NWB: 3BC-ERK----

Re: New Application Acknowledgement for the Eureka Project

Implementation Schedule for Characterization of Contaminated Sites Final Report 2007/2008

Site Coordinates

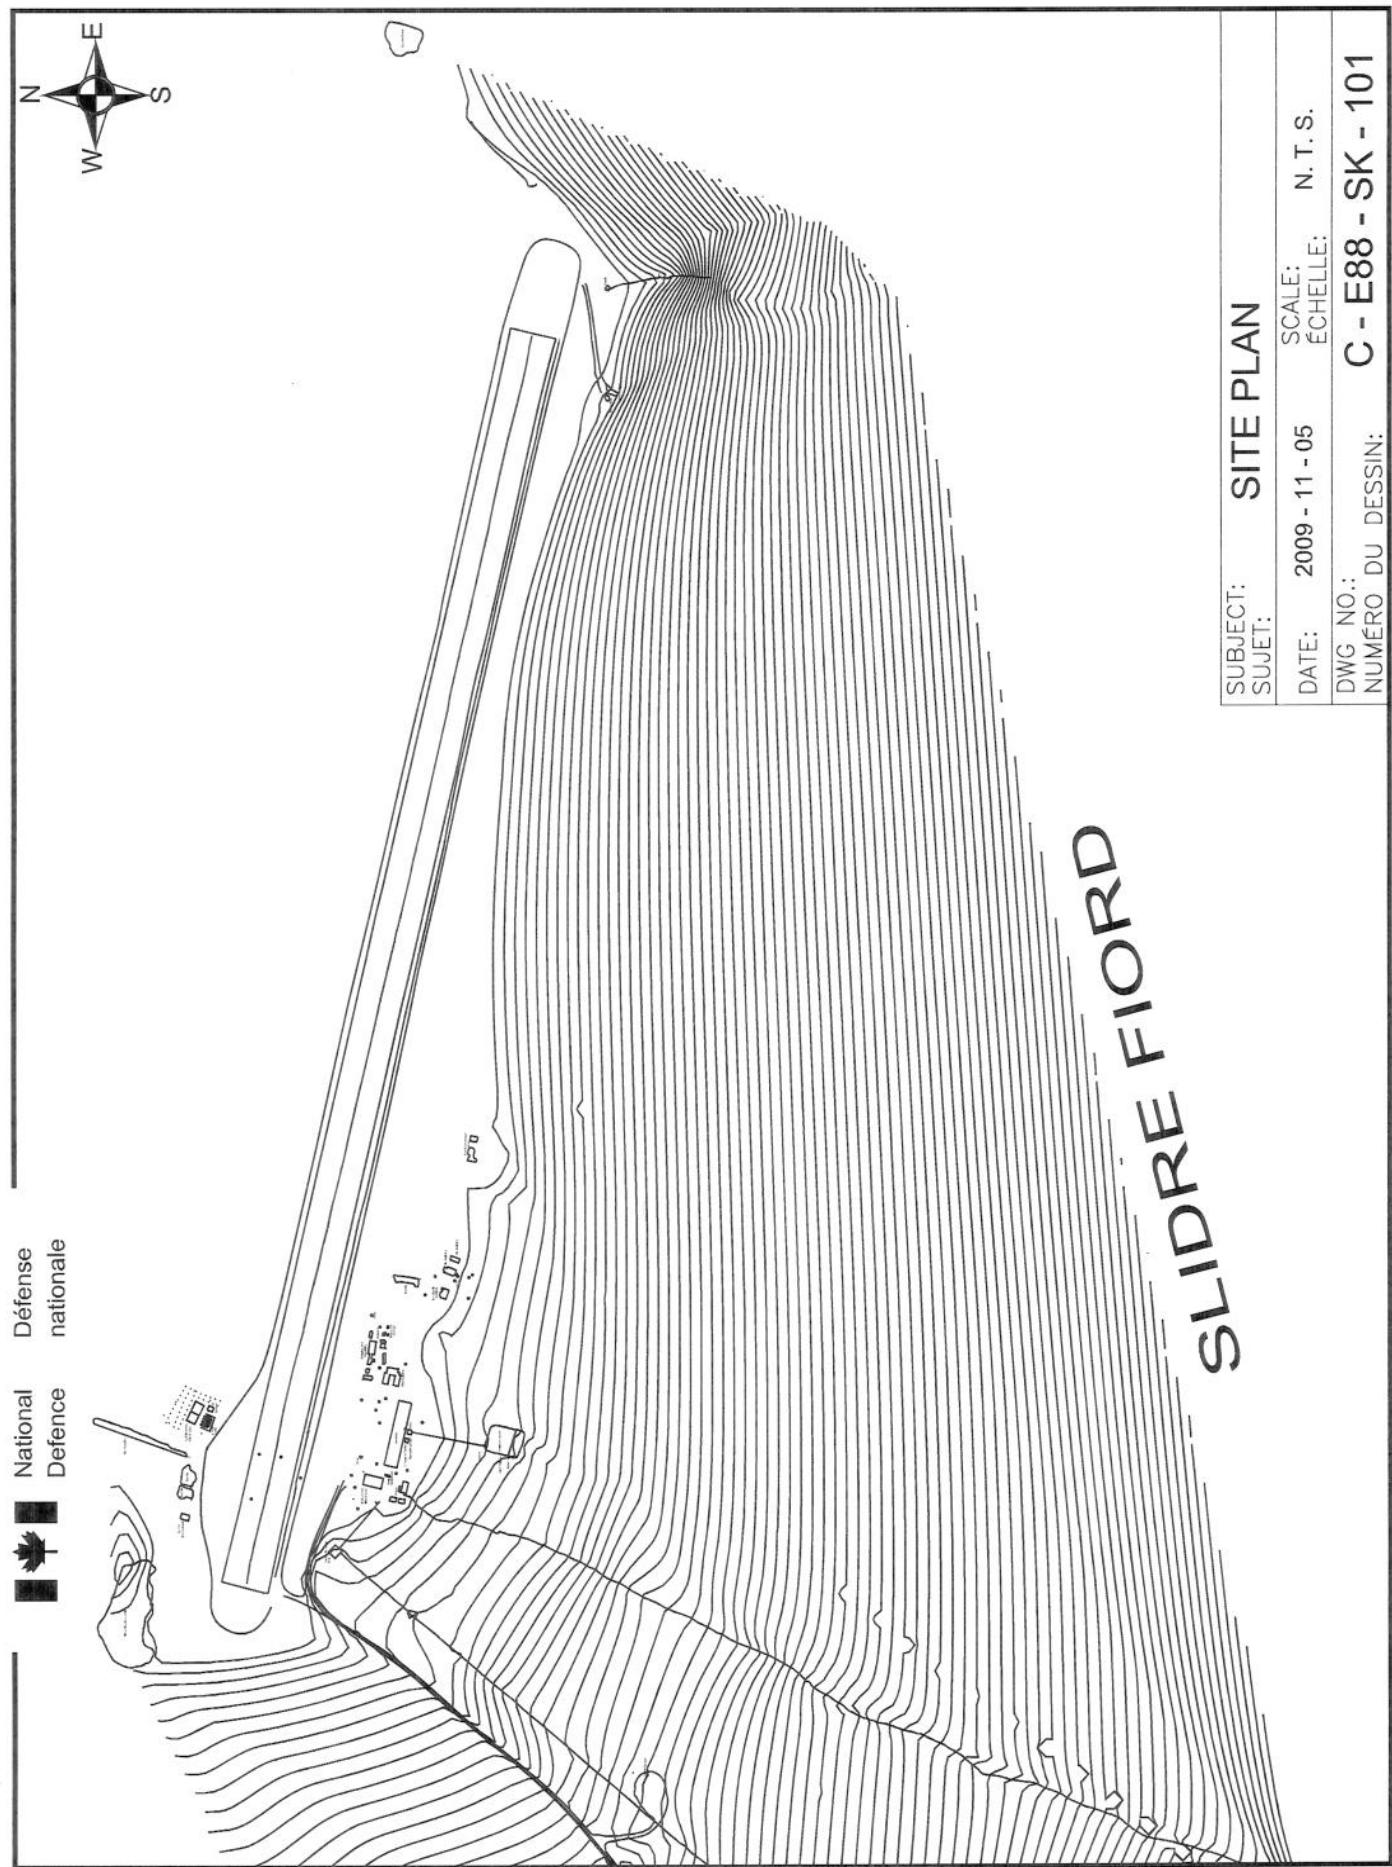
- Full co-ordinates of undertaking in degrees, minutes, seconds
- Site map with labeled facilities and contours and proximity to water bodies
- Implementation schedule for the undertakings if the applicant intends to carry out the remediation activities recommended in the Characterization of Contaminated Sites Final Report 2007/08.
- An engineered design drawing and photo of the lagoon
- East airstrip landfill map and photos

As requested, the full co-ordinates for the site are as follows:

85 degrees, 56 minutes, 30 seconds Longitude

79 degrees, 59 minutes, 20 seconds Latitude
